ASSESSMENT REPORT

Section 75W Modification Amcor Paper Mill, Matraville Site Layout Changes and Subdivision

Figure 3: Proposed McCauley Street Access Changes

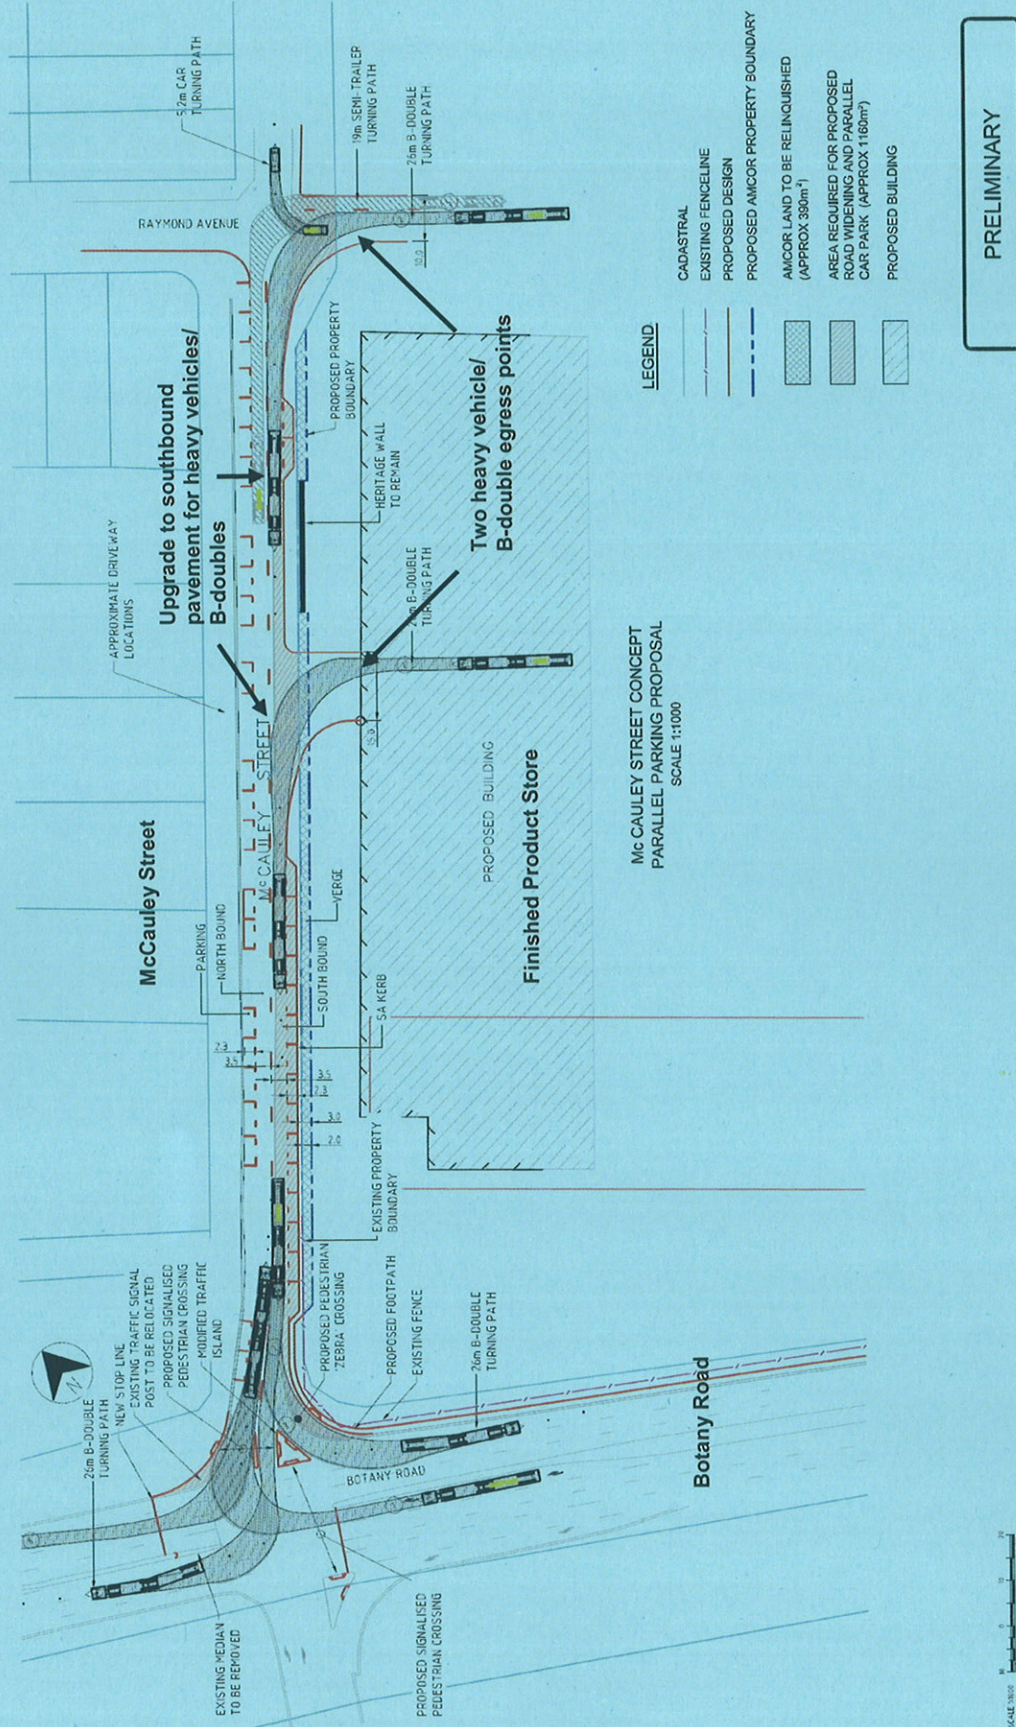
McCauley Street Access Changes

- relocation of the engineering store vehicle access 100m further south along McCauley Street to opposite Raymond Avenue;
- construction and use of an additional B-double vehicle exit on McCauley Street for finished product vehicles, located approximately 70m south of the Raymond Avenue intersection;
- use of these two site access points onto McCauley street for exit of all Amcor heavy vehicle traffic in a southbound direction towards Botany Road; and
- upgrade of McCauley Street between Raymond Avenue and Botany Road to accommodate B-doubles and other heavy vehicles in a southbound direction. Upgrade works would include dedication of Amcor land to Council for provision of adequate road width, parking and a pedestrian footpath.

The proposed changes to site access and the McCauley Street upgrade works are shown on Figure 3.

Figure 4: Proposed Site Layout

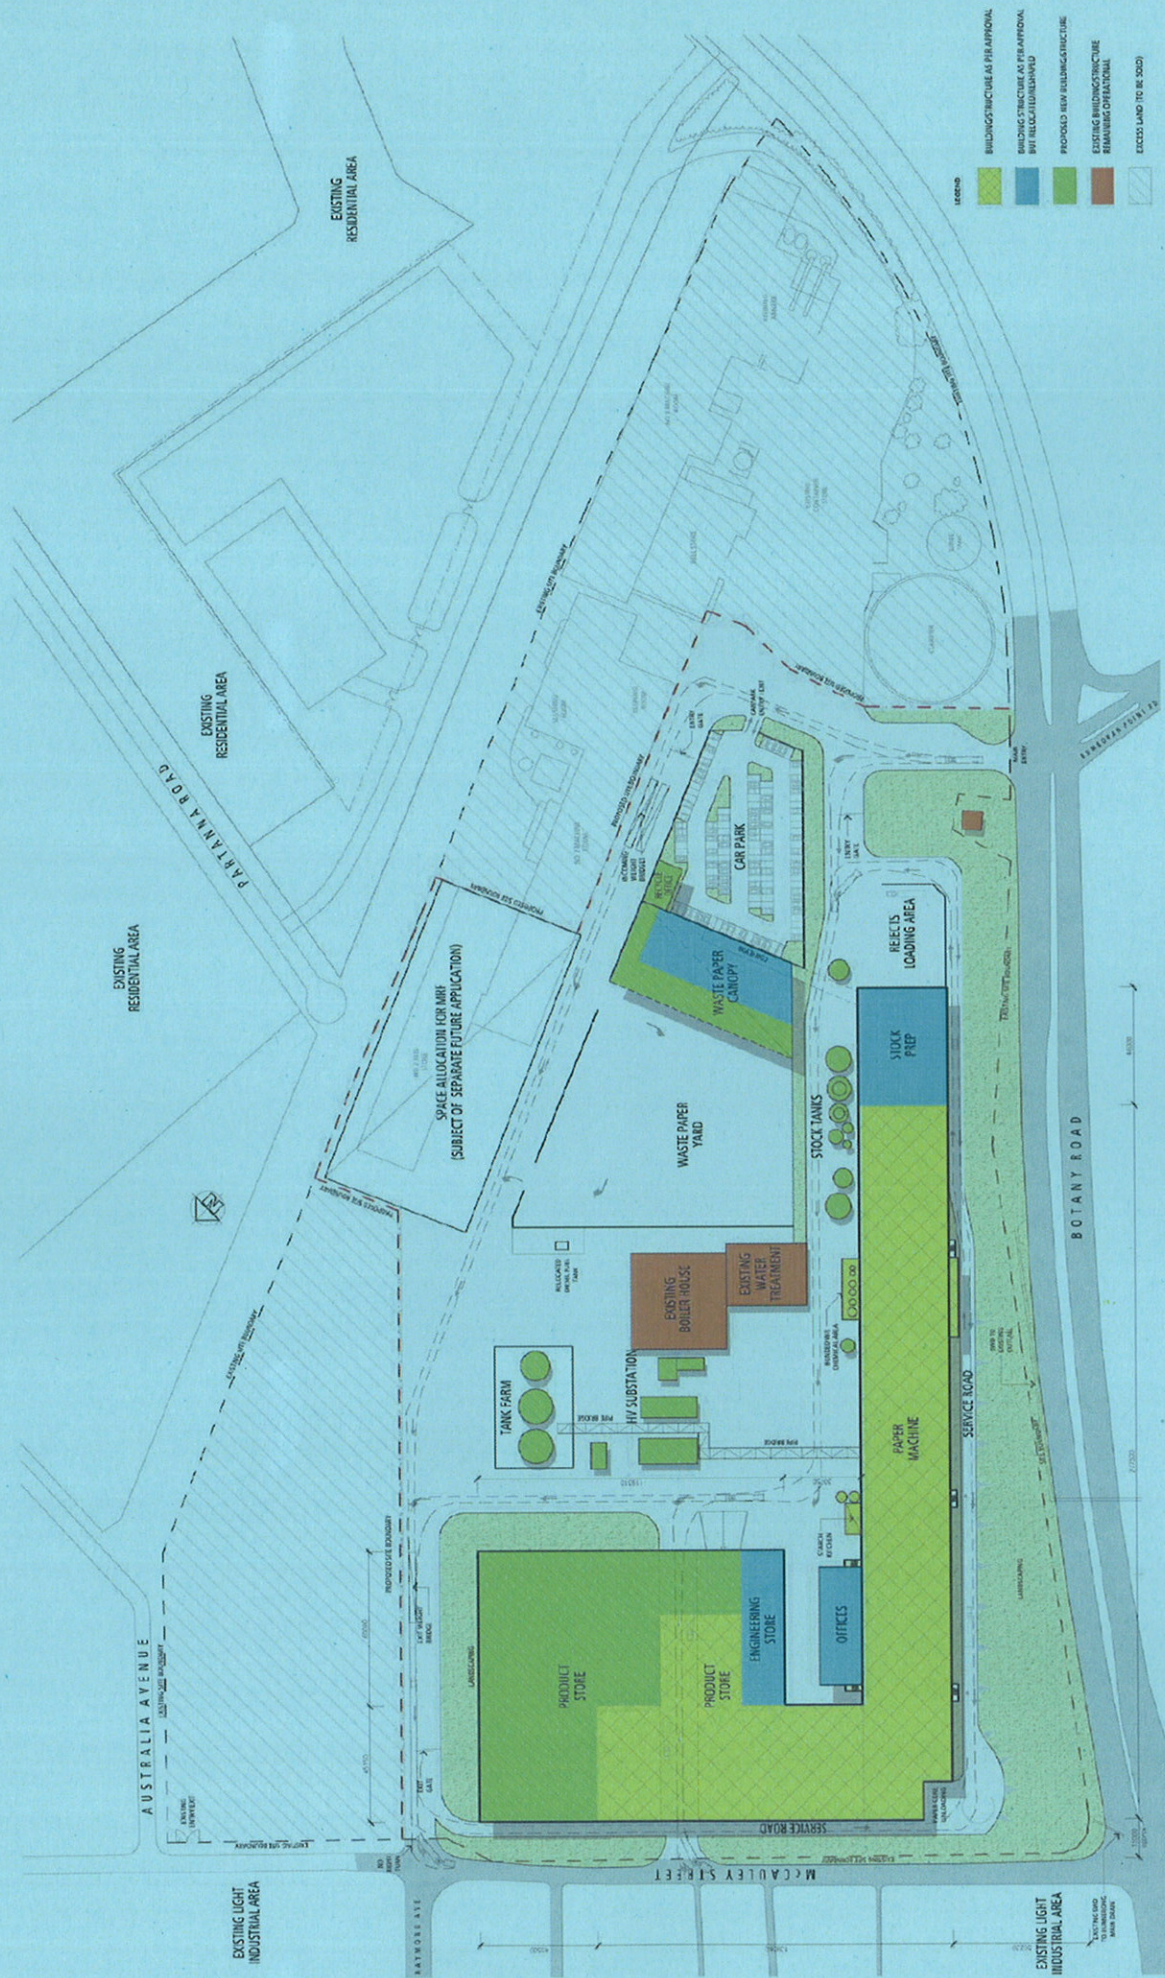
Internal Site Layout Changes

- Increase the size of the finished product store from 5,000m² to 10,000m² and accommodate loading of finished product vehicles within the store building;

- Extend the new paper machine building by 45m to the east along the Botany Road frontage;
- Construct a new car park at the eastern end of the waste paper yard;

- Demolish part of the existing stock preparation plant, repave and use as the waste paper yard;
- Roof a section of the waste paper yard;
- Relocate the paper machine roll store to the western end of the paper machine building;

- Construct a fully enclosed annexe on the south side of the paper machine building to house vacuum blowers;
- Relocate the control room, offices and maintenance area further west on the northern side of the paper machine building;

- Relocate various stock and process water tanks to the eastern end of the paper machine building; and
- Relocate the engineering store adjacent to the finished product store.

The proposed site layout changes are shown in Figure 4.

Figure 5: Proposed Subdivision

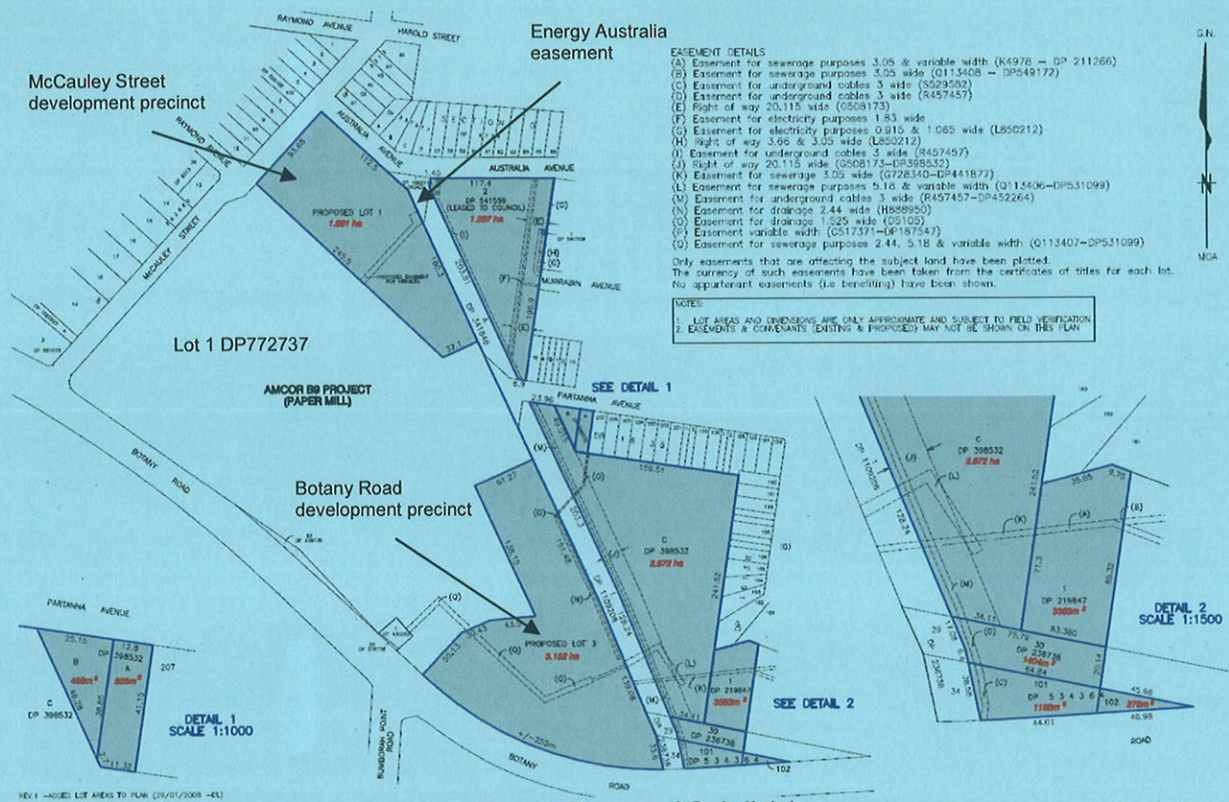
Amcor is seeking to subdivide the site to enable excess land to be sold to fund development of the new paper mill. Amcor proposes to subdivide the largest land parcel, Lot 1 DP772737, into three lots, all zoned for industrial use and comprising:

- the Amcor site including the new paper machine building and other approved infrastructure;
- the McCauley Street development precinct, covering 1.99 hectares bound by McCauley Street and Australia Avenue and referred to as proposed Lot 1; and
- the Botany Road development precinct, 3.15 hectares, currently housing the existing paper machine buildings (No. 7 and 8) that would be demolished, referred to as proposed Lot 3.

A subdivision plan is shown in Figure 5. Note the separate lots to the east of the Energy Australia easement are not part of the modification application, as they are already on separate titles.
